STAFF RECOMMENDATION

1206 6th Avenue North

April 20, 2016

Application: New construction—infill; Setback determination

Figure 1. 1206 6th Avenue North, vacant lot.

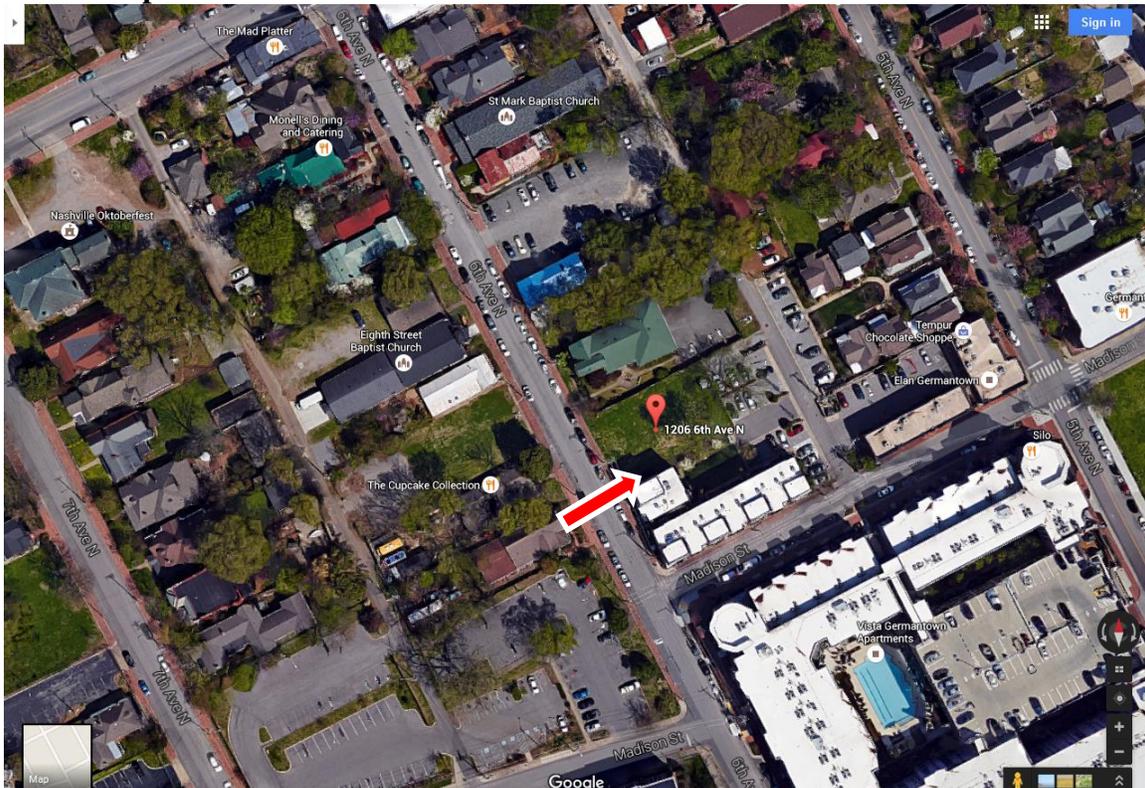
Background: 1206 6th Avenue North is a vacant lot (Figure 1). It is seventy feet (70’) wide at the front and approximately one hundred and ten feet (110’) deep. The lot is zoned MUN.

FIRST FLOOR PLANS

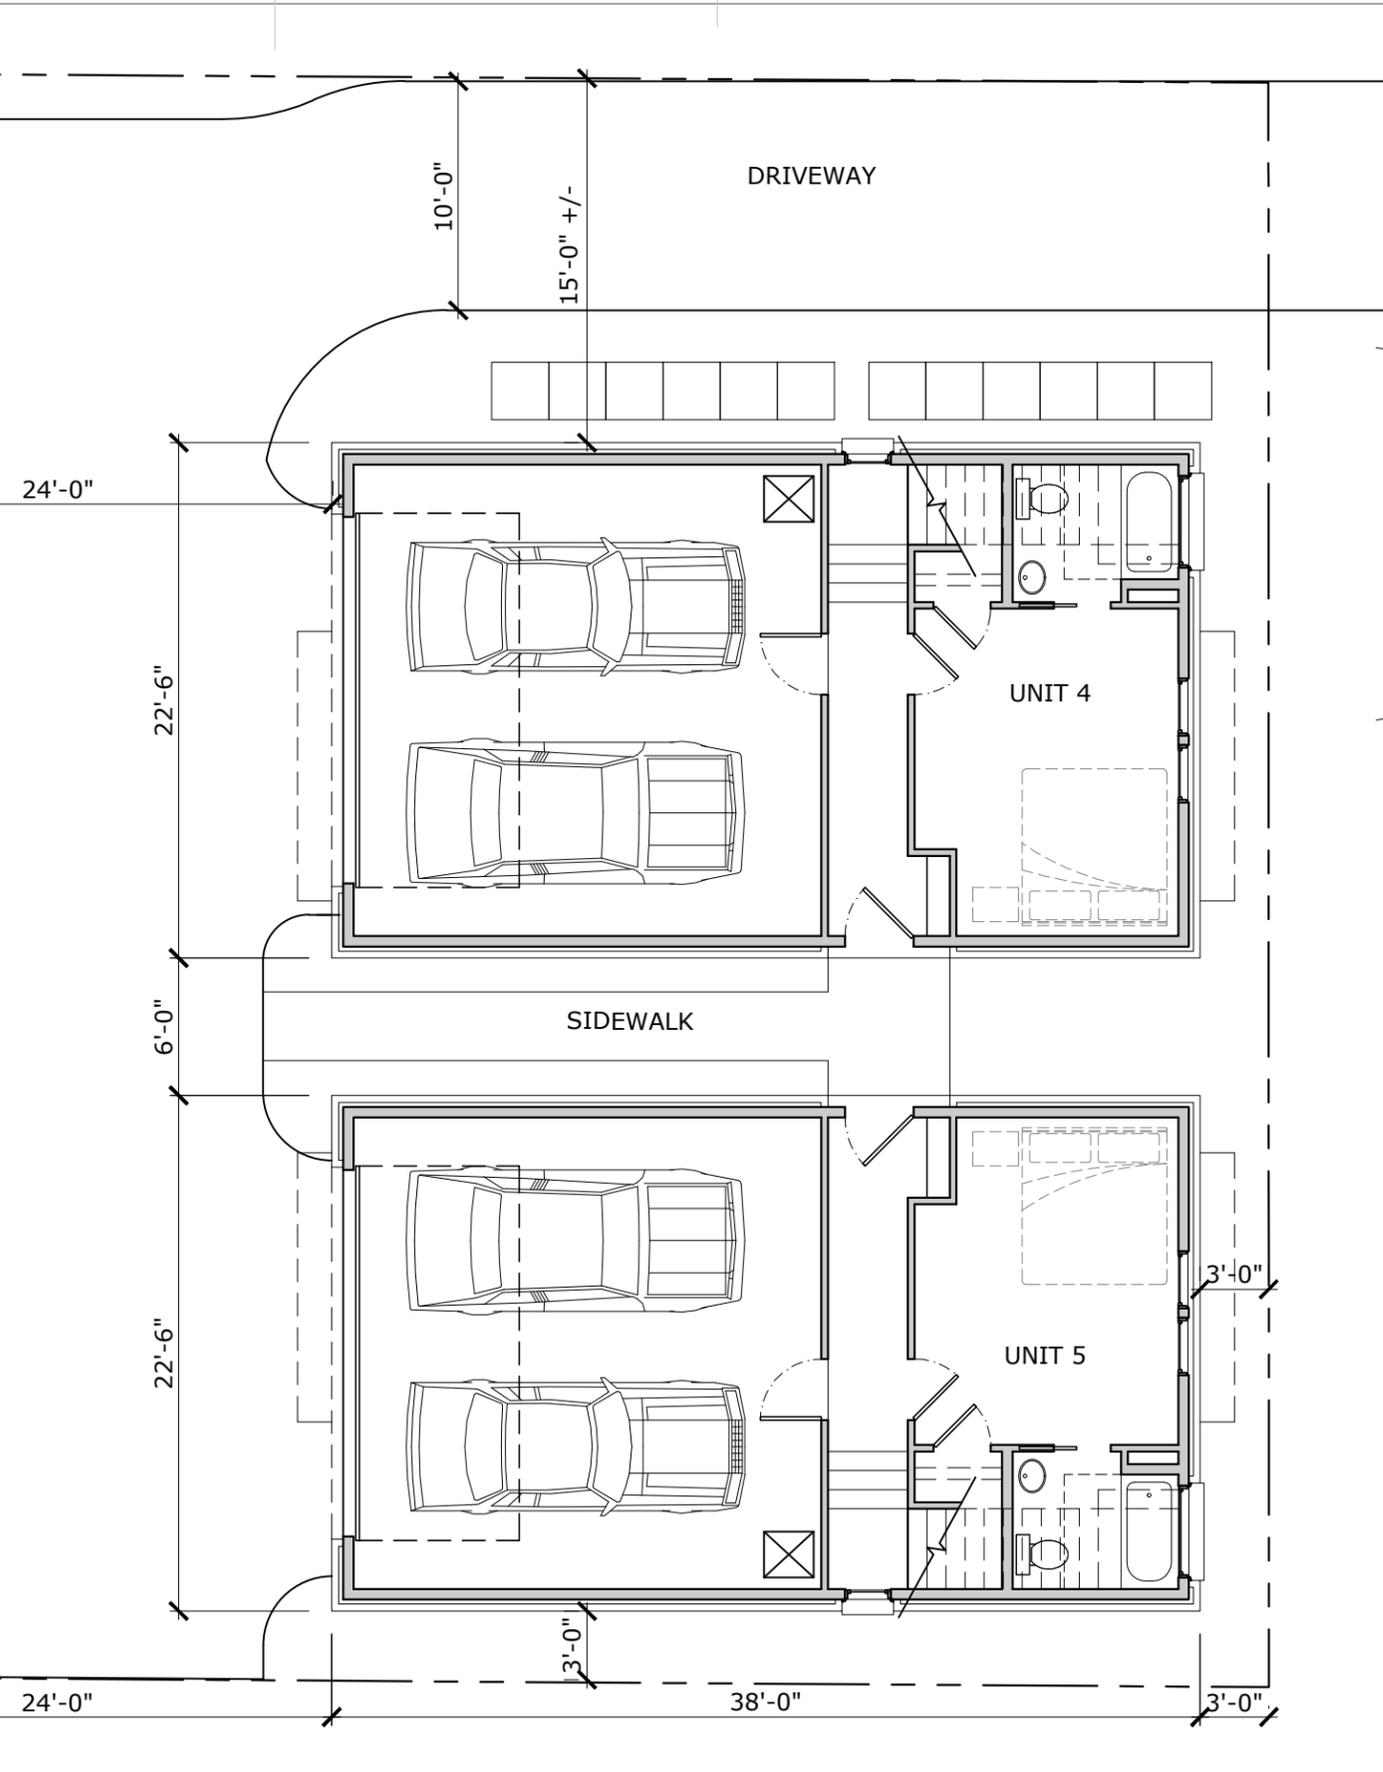
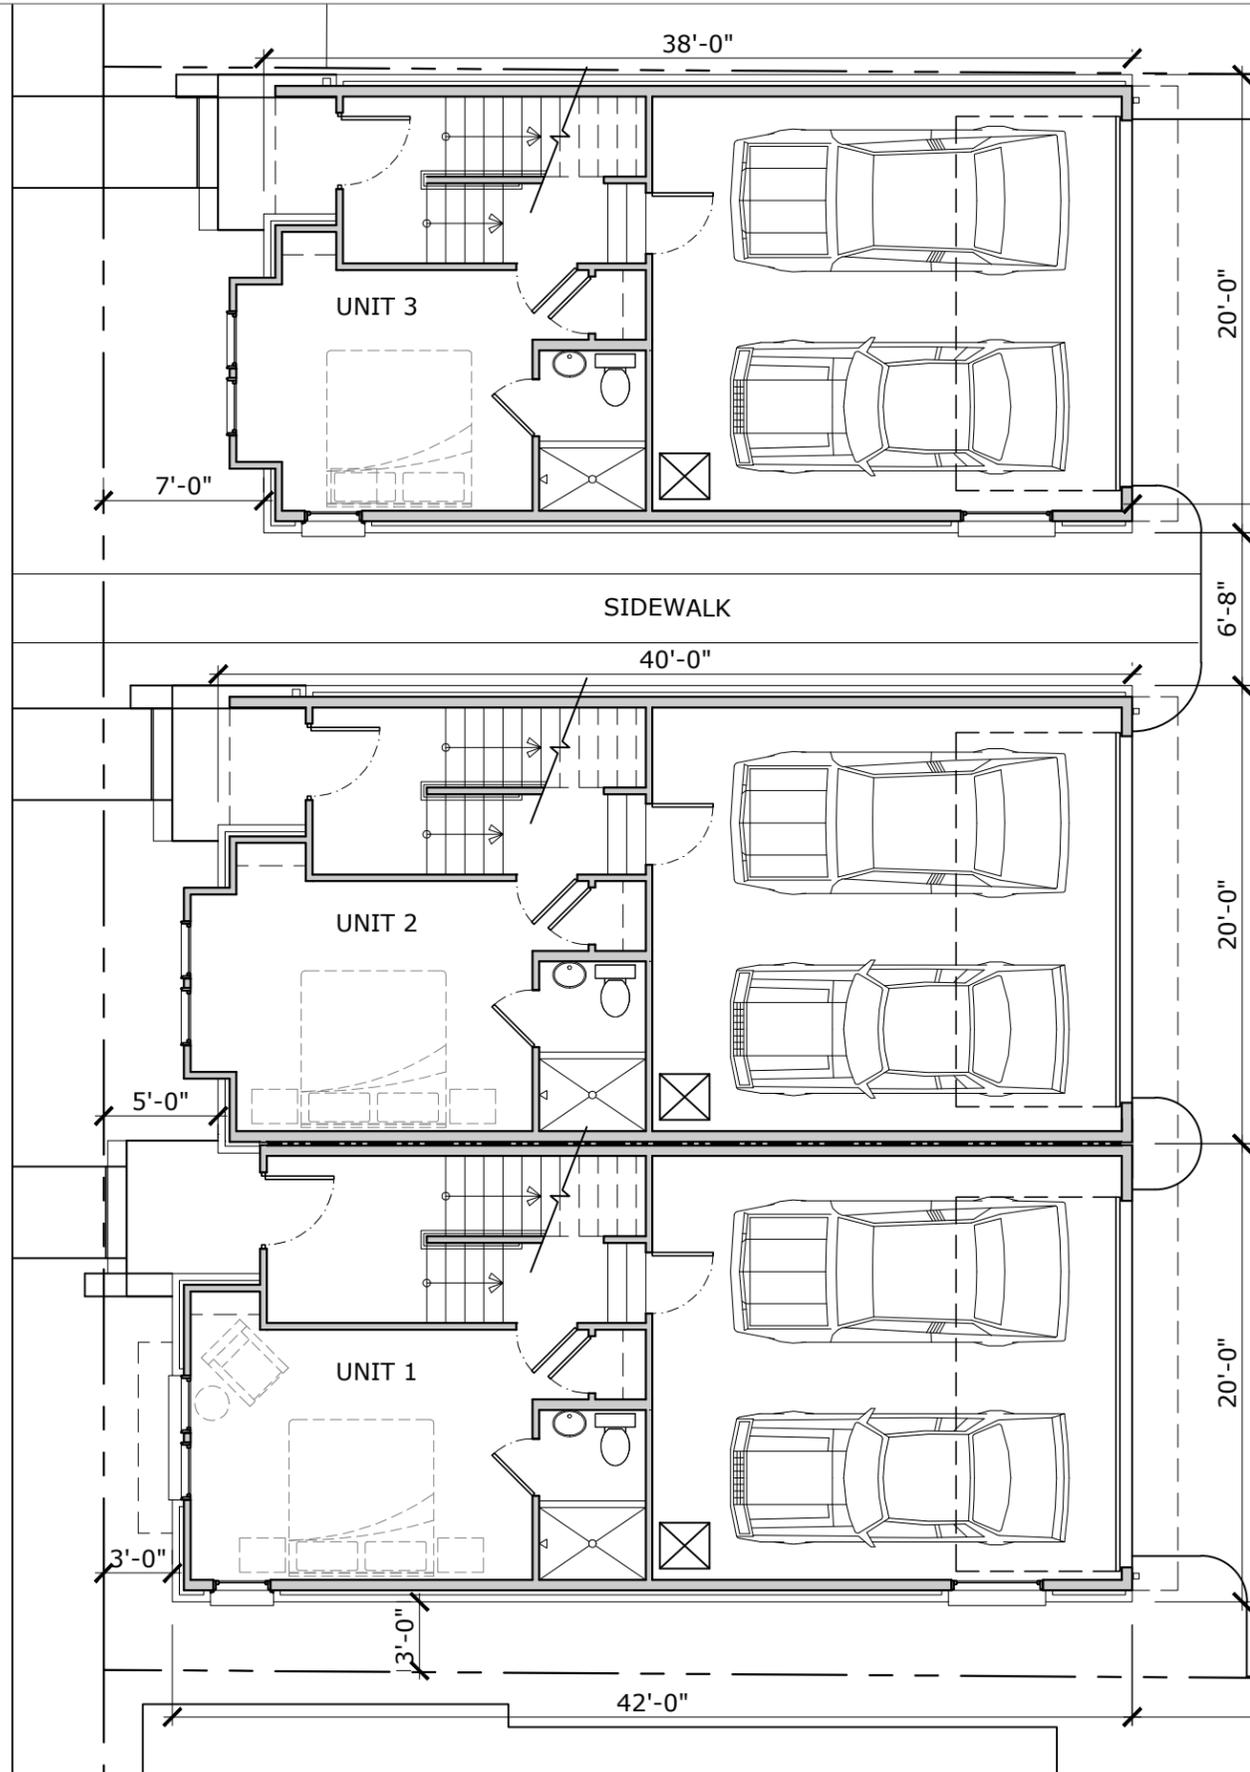
Utilities/Mechanical. No location for the mechanicals and utilities were indicated on the site plan, and staff recommends that they be place at the rear or on the townhouse roofs, hidden by the parapet wall.

Fences, walls, and other appurtenances. A walkway between the middle and the northernmost unit is proposed to lead from the sidewalk on 6th Avenue North to the interior of the lot. Another sidewalk will be located in between the two rear units.

Pavers are indicated in between the driveway and the rear unit number 4, and staff recommends review of the paving material. Staff also recommends approval of the final driveway and interior court yard design. No fencing or walls were indicated on the site plan, and staff will want to review all fencing, walls, and other appurtenances to ensure they meet Section 5.1 of the design guidelines.

6TH AVE N EVELATION

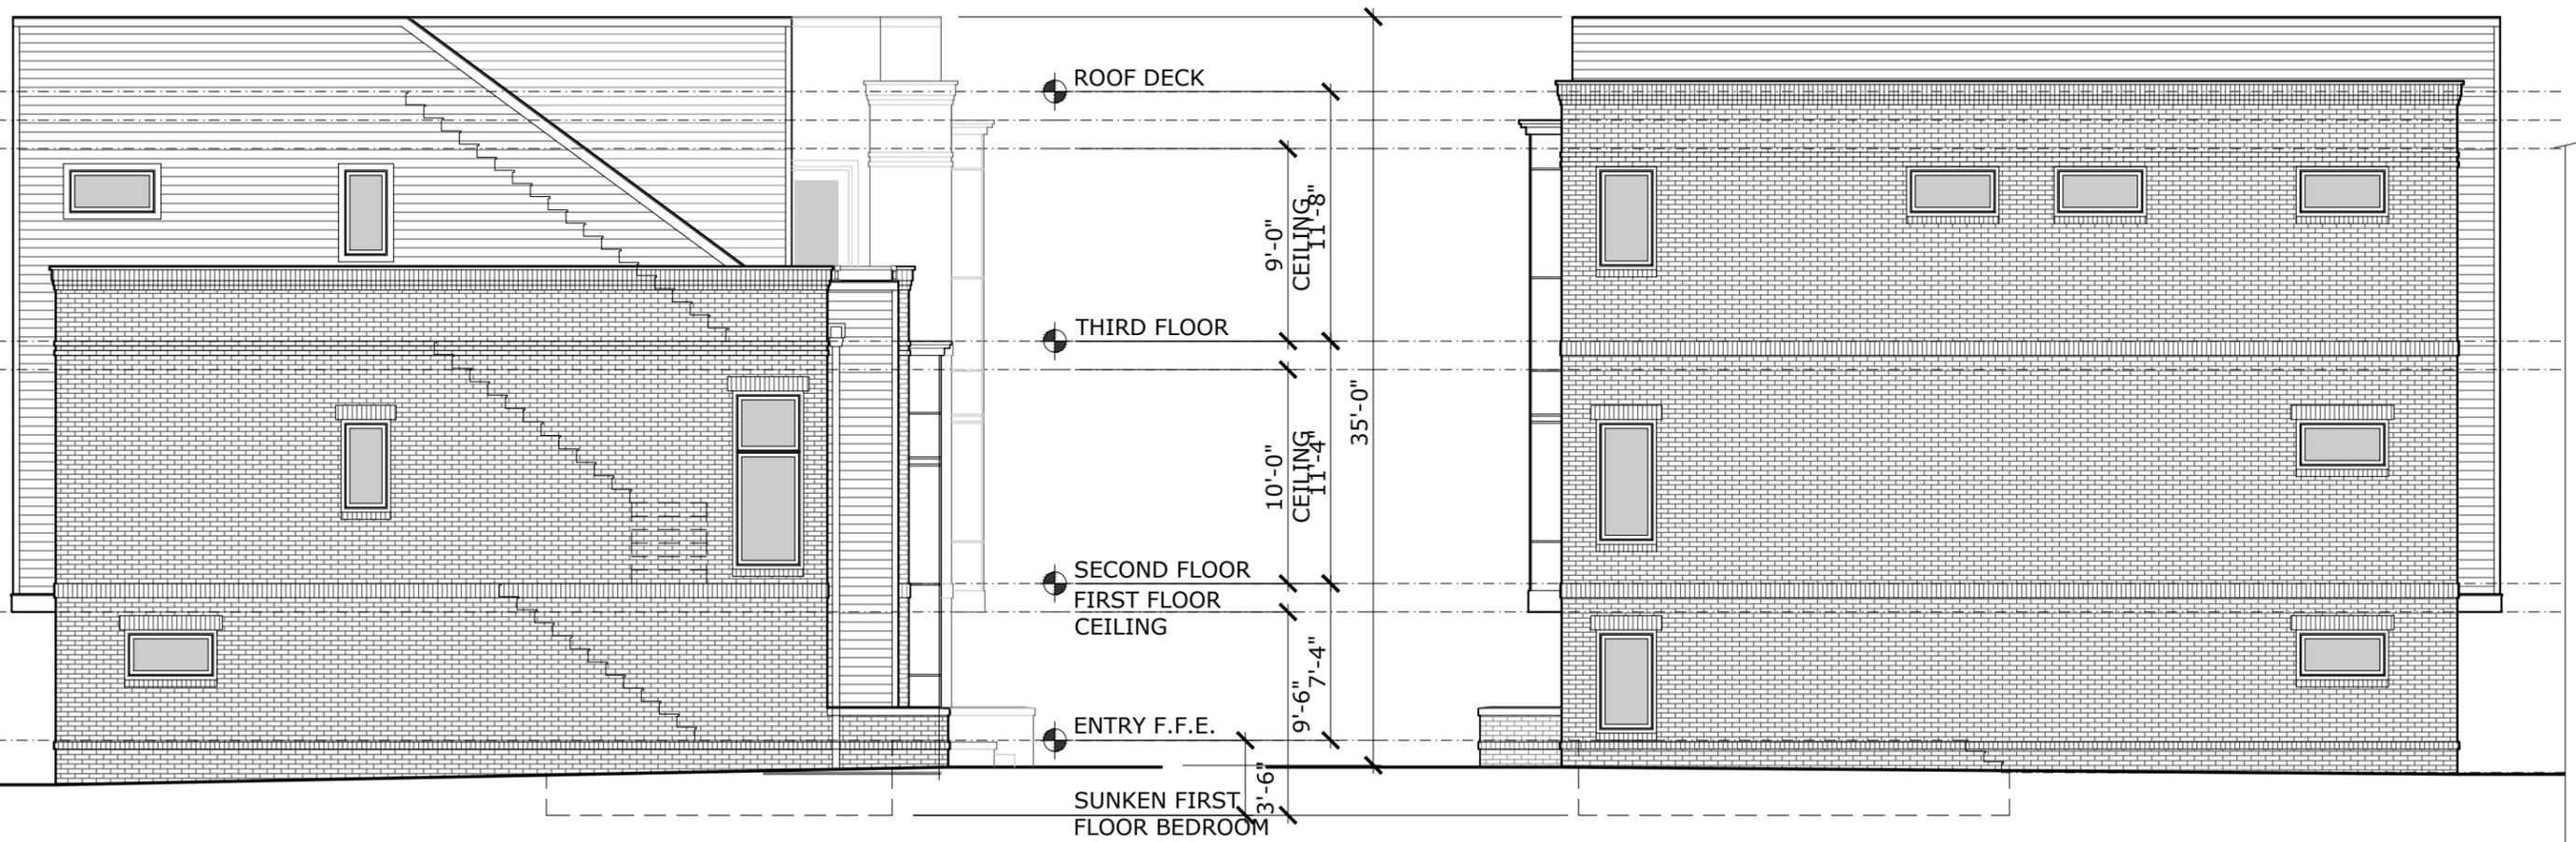
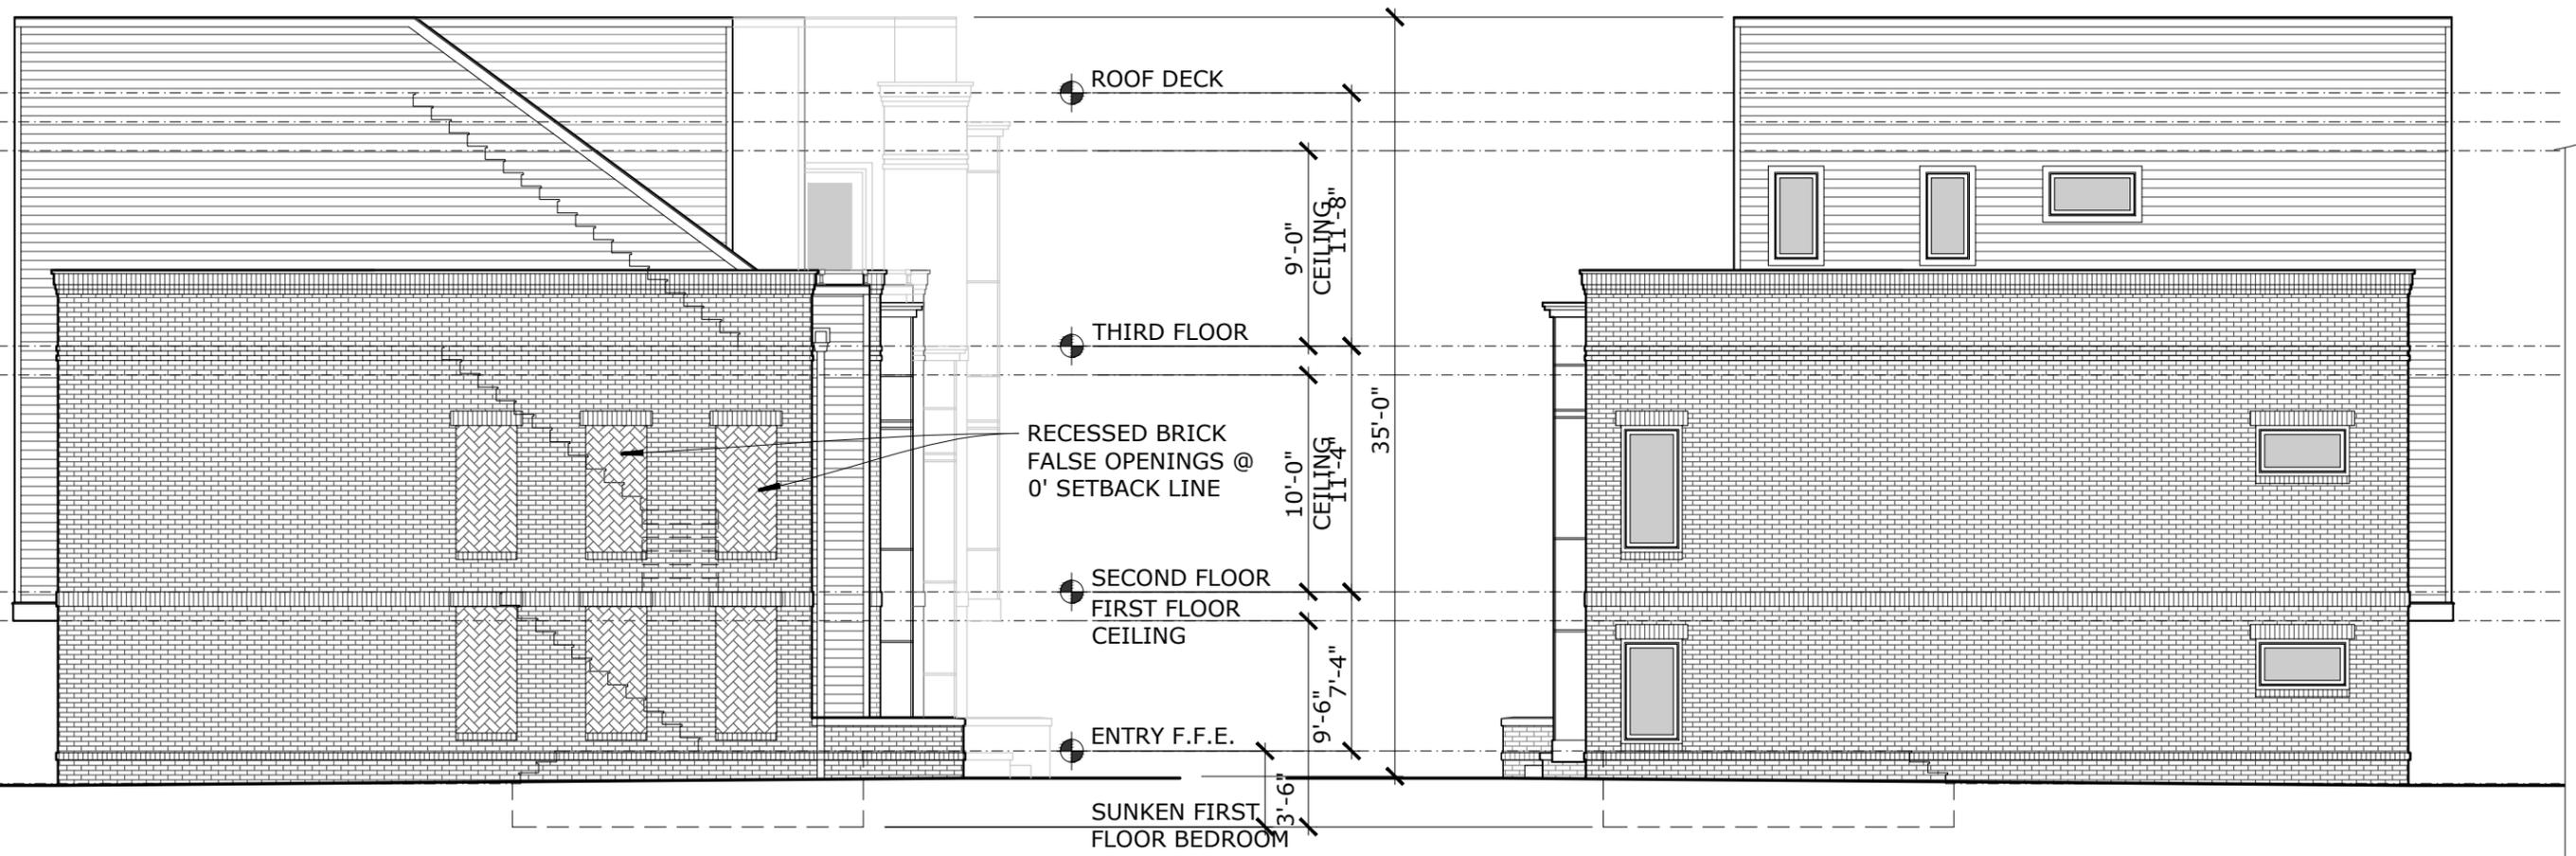
Massing, Scale, and Height. The two southernmost 6th Avenue North townhouses are attached, with a total width of forty feet (40'). The third unit will be separated from the other two units by a seven foot (7') wide walkway, and this townhouse will be twenty feet (20') wide. Staff finds that this width meets the historic context, as the site serves as a transition from the multi-family development at the corner to the smaller-scale single family houses on the interior of the lot and the break between the units allows for pedestrian access to the rear units. The historic houses on the block have widths that range from twenty-one feet to forty-six feet (21'-46'), and staff therefore finds that the proposed widths are appropriate. The three front townhouses will be between forty and forty-two feet deep (40'-42') deep.

The southernmost townhouse unit will be three stories in height, but the other two townhouses will be two stories tall, with a recessed third story. All three townhouses will have a maximum height of thirty-five feet (35'). Staff finds the three story townhouse to be appropriate because the c. 2007 infill next door is three and a half stories in height and approximately forty feet (40') tall. The step-backed upper levels will help the development transition from the taller infill on the corner to the smaller-scale historic houses on the interior of the block.

The two other townhouses will be two stories and approximately twenty-three feet (23') tall at the front. Third stories plus a roof deck are added, recessed from the front wall of the townhouses. The middle townhouse's third story is recessed between five feet, six inches and seven feet, six inches (5'6"-7'6") from the front wall of the house, and the northernmost townhouse's third story is recessed between seven and nine feet (7'-9') from the front wall of the house.

Materials. The primary façade material will be brick, and staff recommends approval of a brick sample. Five inch cement fiber board lap siding, stucco, and cypress rainscreen siding will be used as accent materials. The windows will be Marvin Integrity windows or other metal clad windows, and staff recommends review and approval of the final window and door selections prior to purchase and installation. The entryway step and floor will be concrete. The balcony handrails will be steel. Staff recommends approval of the material of the pathways and interior courtyard pavers. With the aforementioned staff approvals, staff finds that the proposed materials meet Section 2.4 of the design guidelines.

Windows and Doors. The window and door openings are all appropriately recessed for a brick structure. The proposed infill's windows are generally twice as tall as they are wide, thereby meeting the historic proportion of window openings. The side facades of the front townhouses will have few window openings on them, which can be typical of townhouse development, particularly when a façade sits on or near the property line. The north façade of the northernmost townhouse will have faux window openings, filled with brick in a herringbone pattern. Staff finds this to be appropriate because actual window openings are not permitted on the property line under building code, and faux window openings on brick facades are a feature seen historically in Germantown. The rear townhouse fenestration pattern will not be highly visible from the street. Staff finds that the proposed windows and doors meet Sections 2.5. and 2.6. of the design guidelines.
